# J.R. Holzmacher P.E., LLC

October 14, 2014

**Re:** VCP # 15CVCP022Q  
E-Designation # 14EH-N158Q  
140-35 Queens Boulevard  
Remedial Action Work Plan (RAWP) Stipulation List

**Appendix 6**  
Drawings of The Composite Site Cover

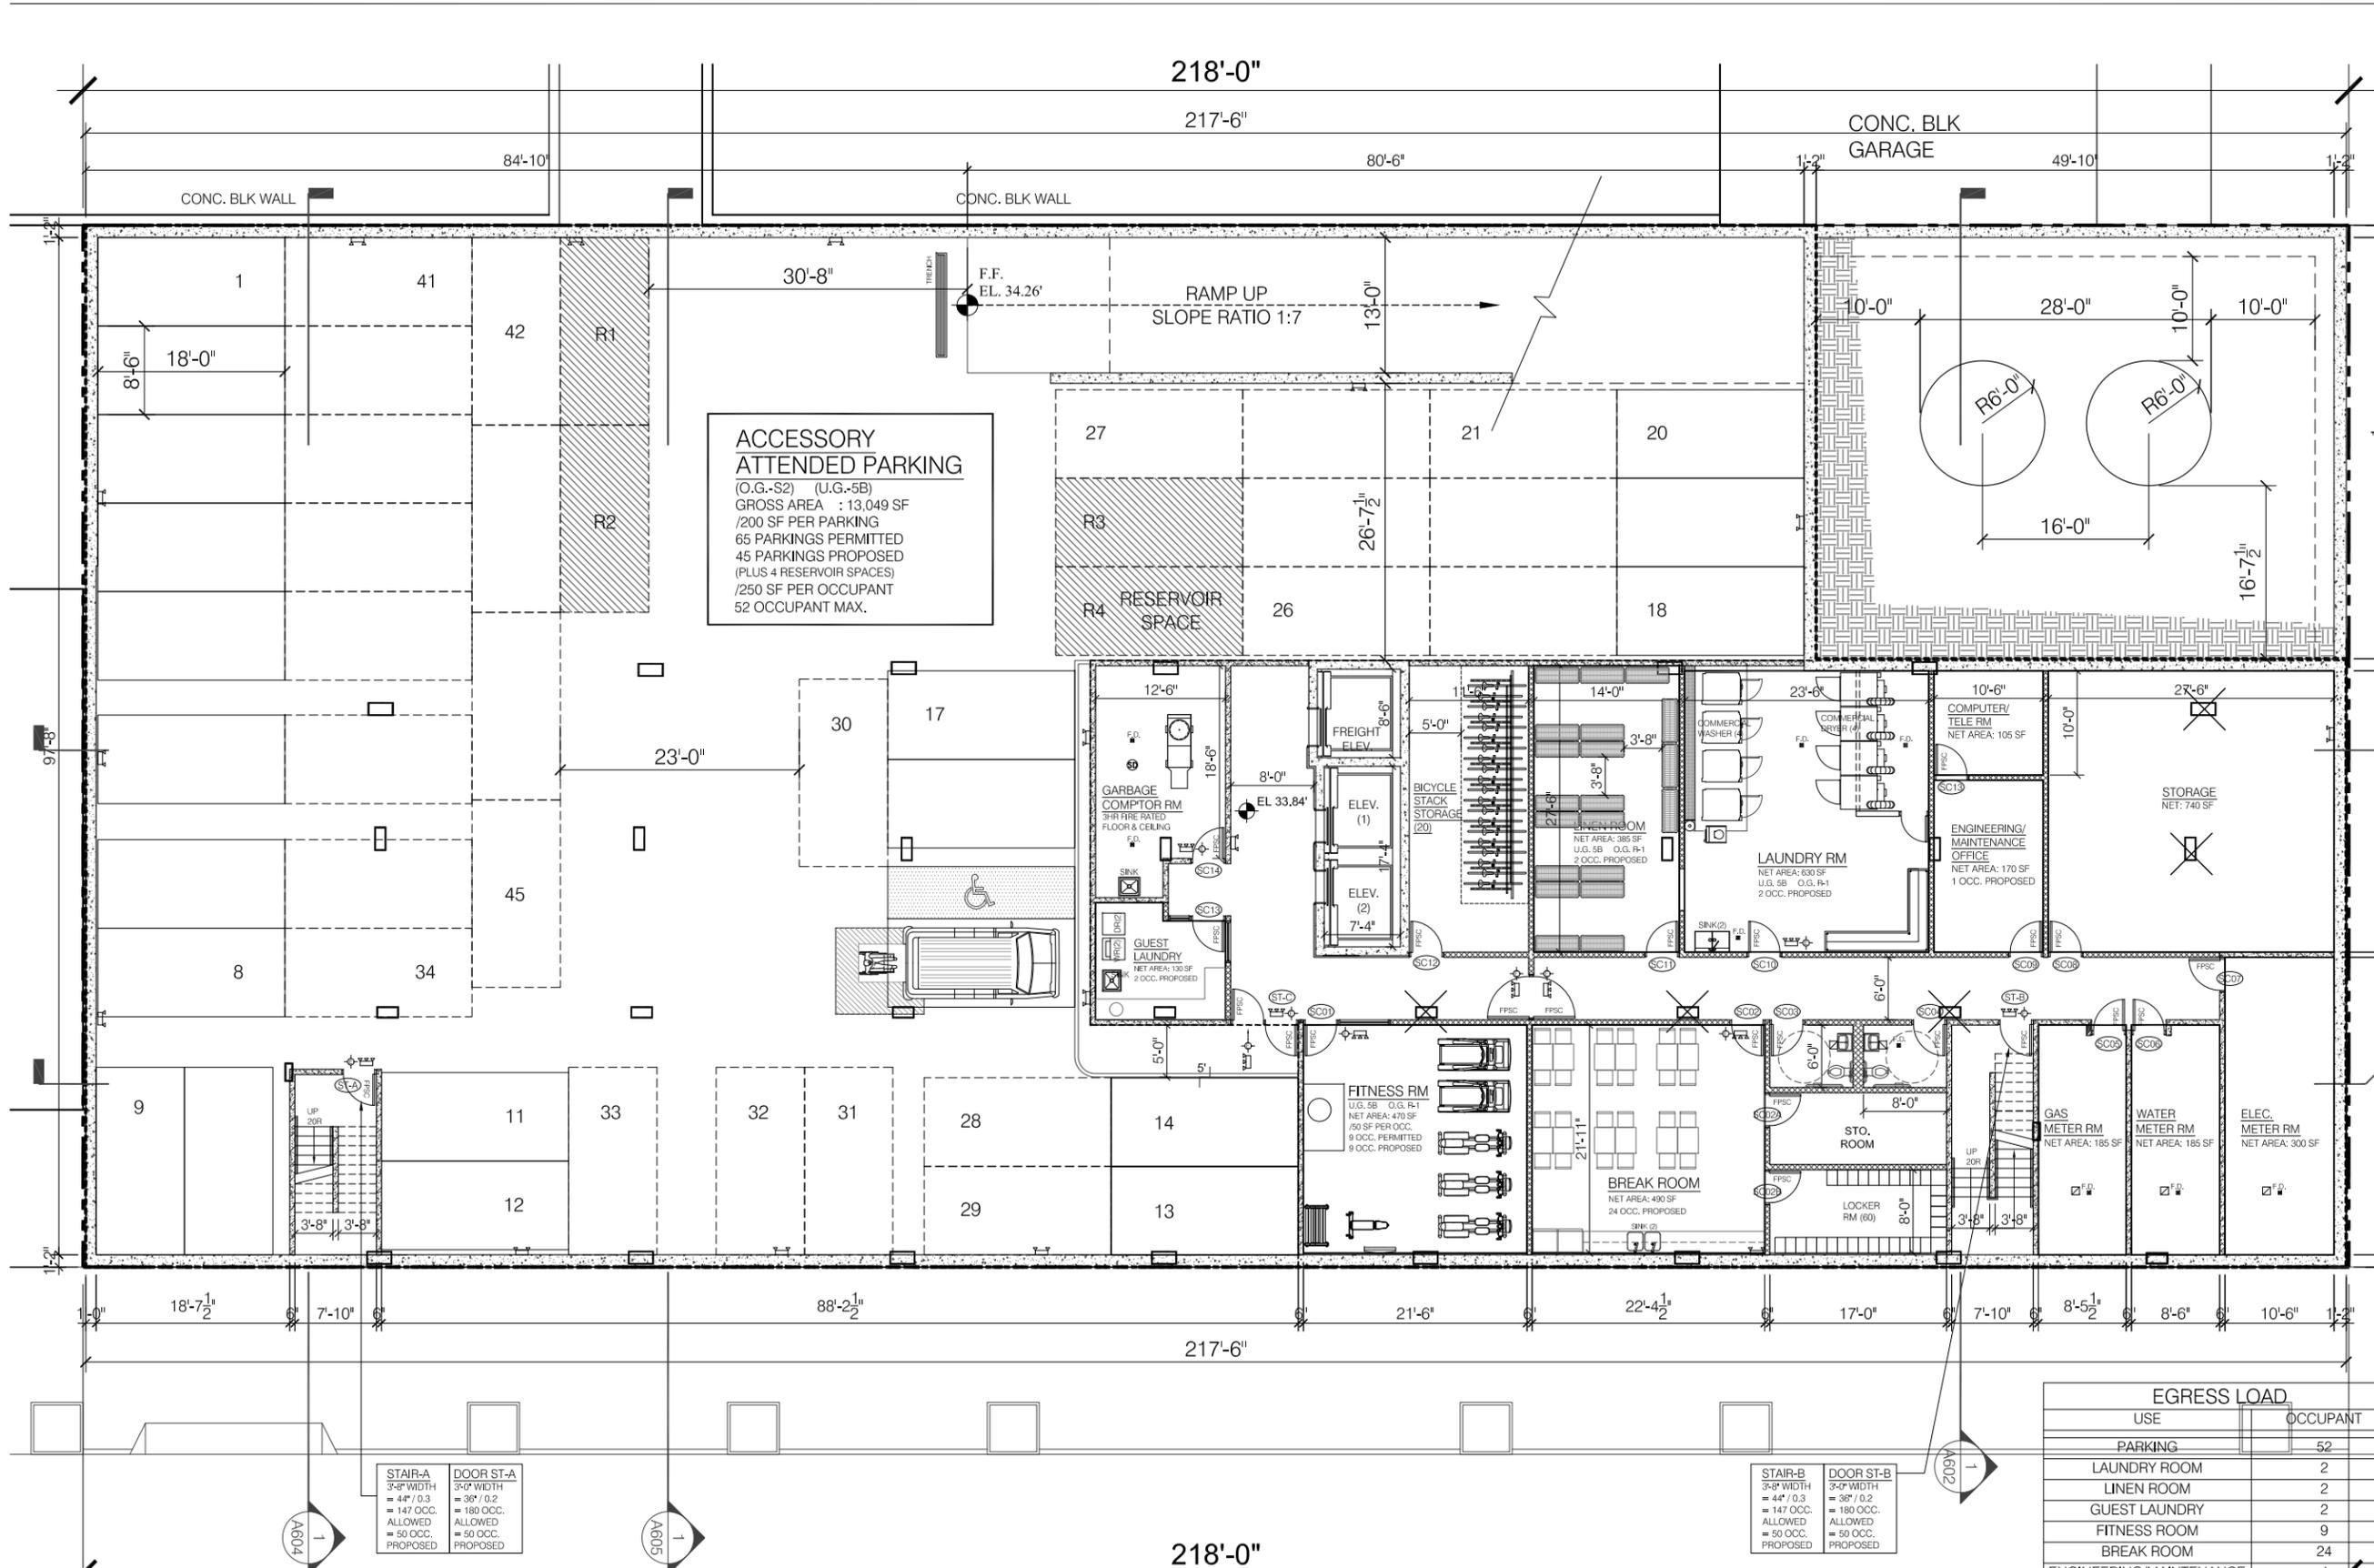
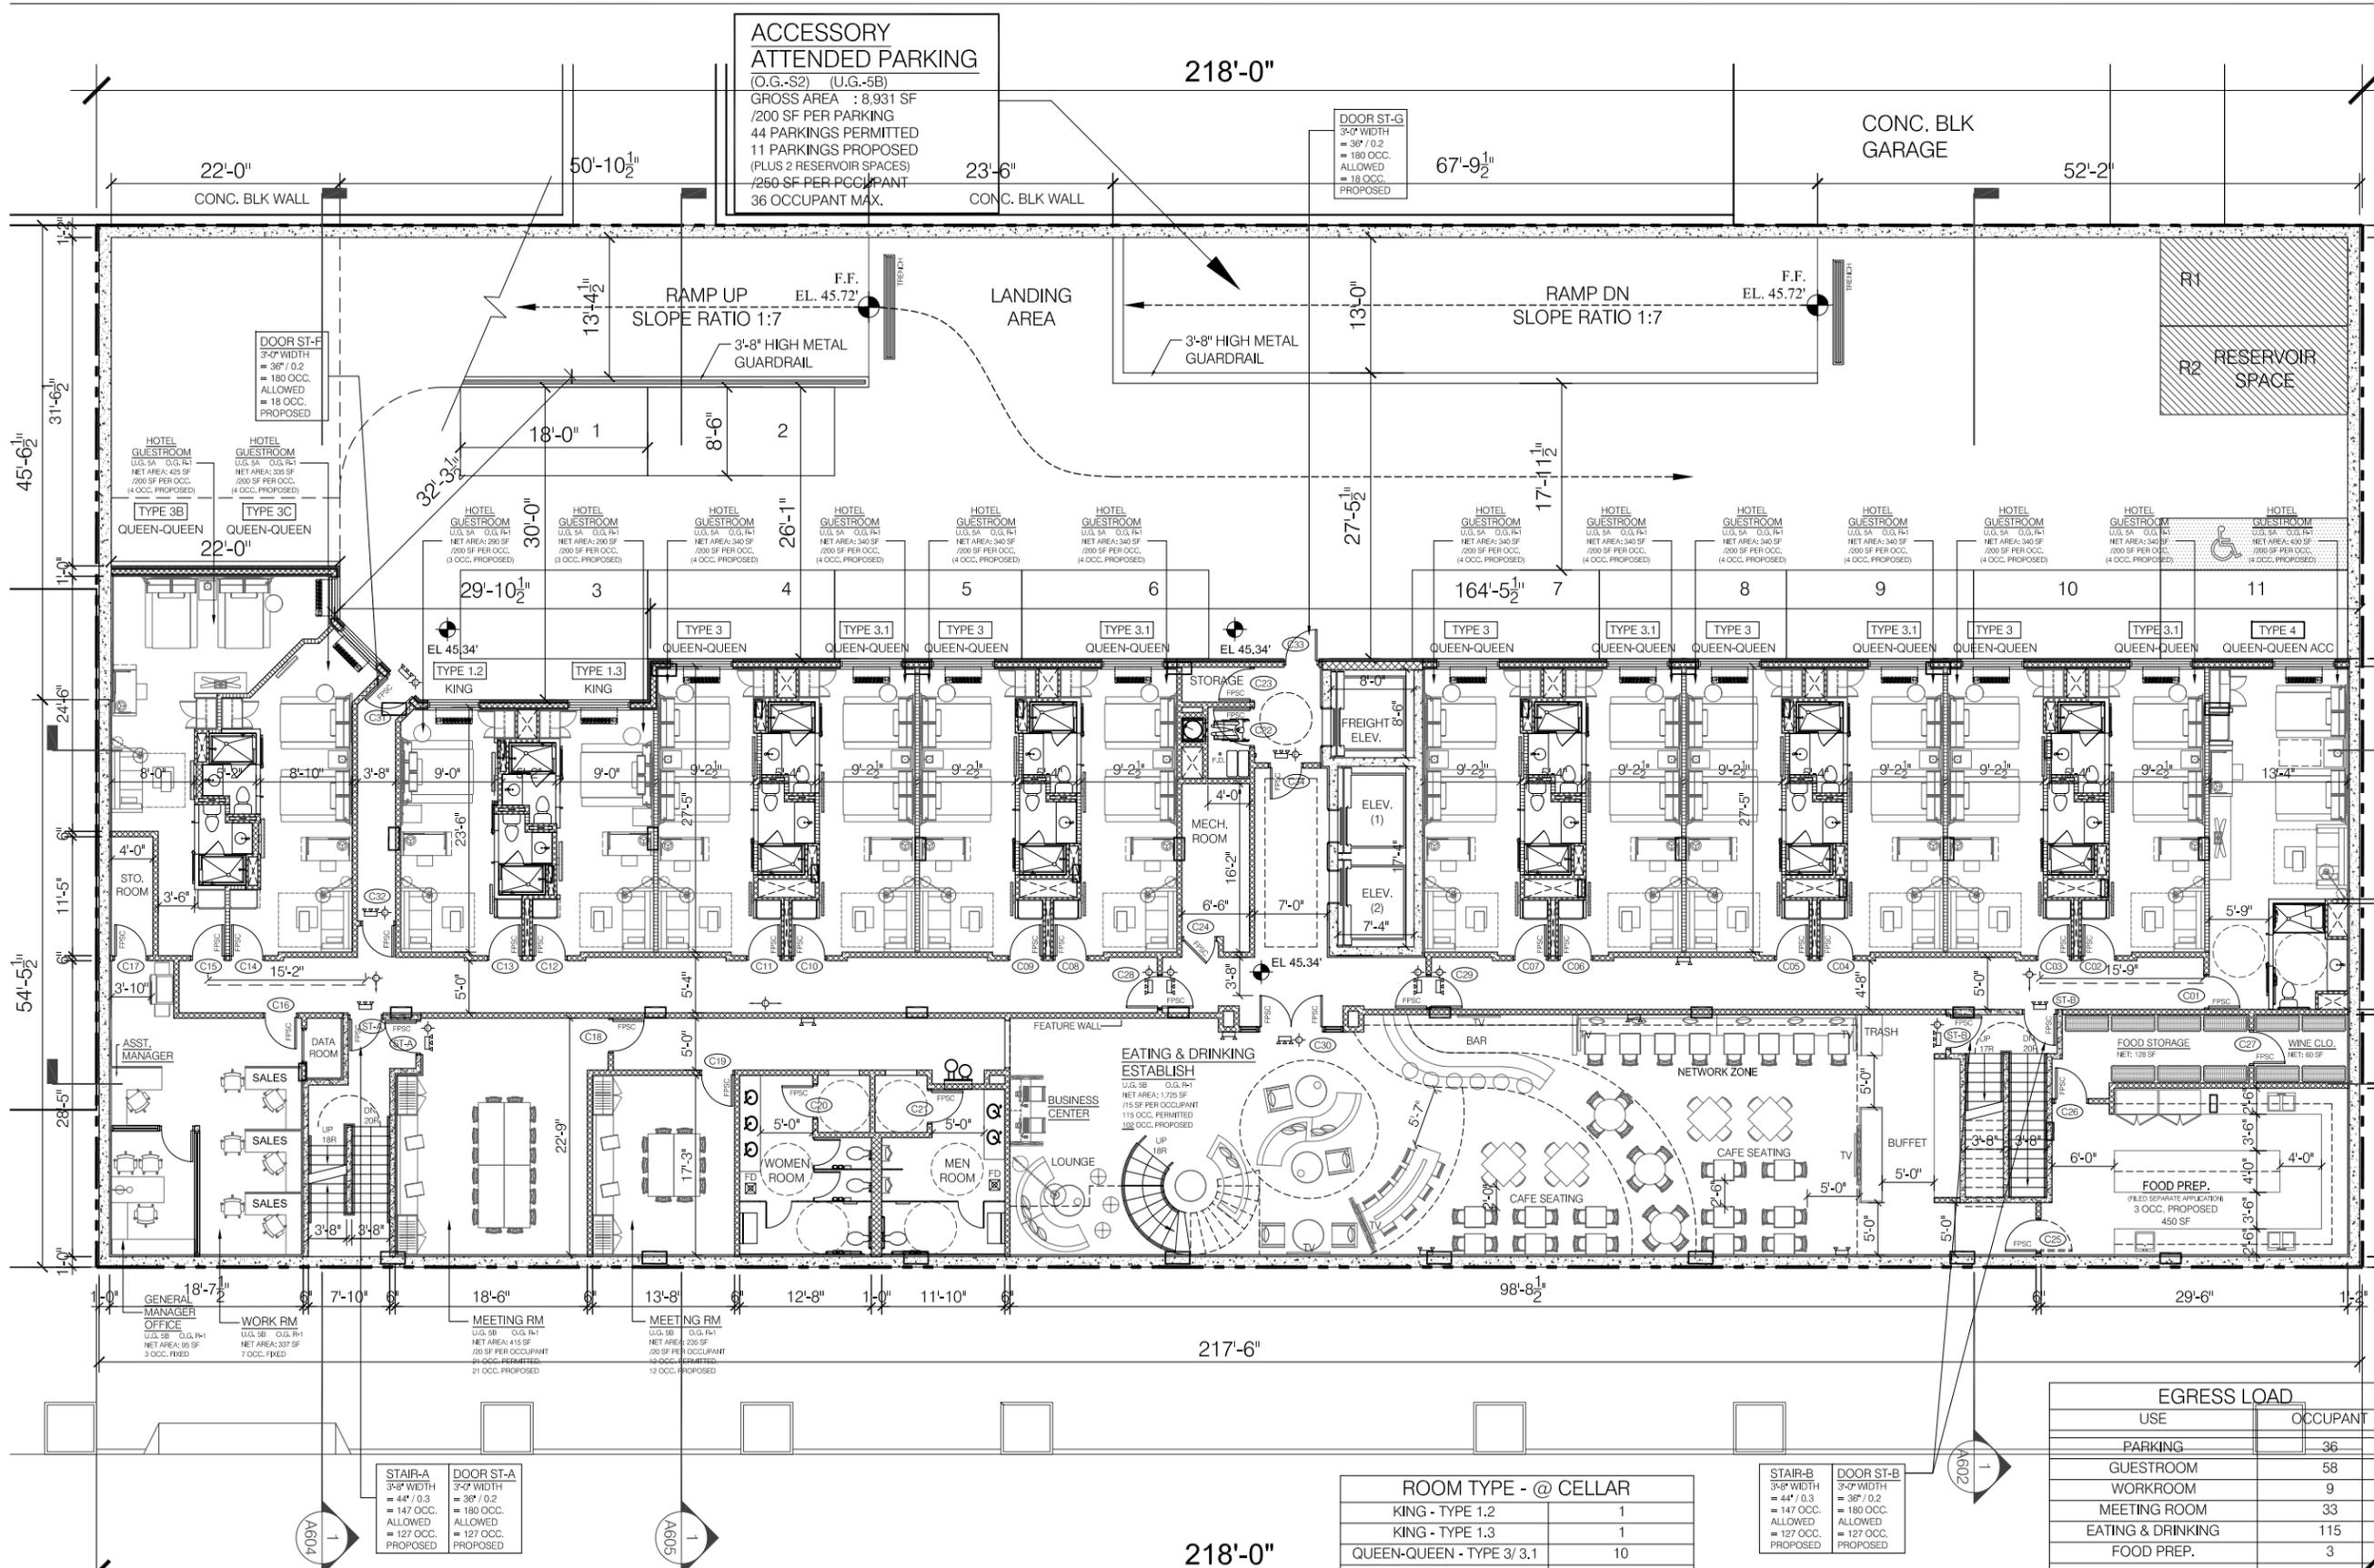
9. An engineered composite site cover will be placed over the entire footprint of the Site. The composite cover system will be comprised of concrete foundation/slabs. Drawings of the composite site cover are provided as **Appendix 6**.
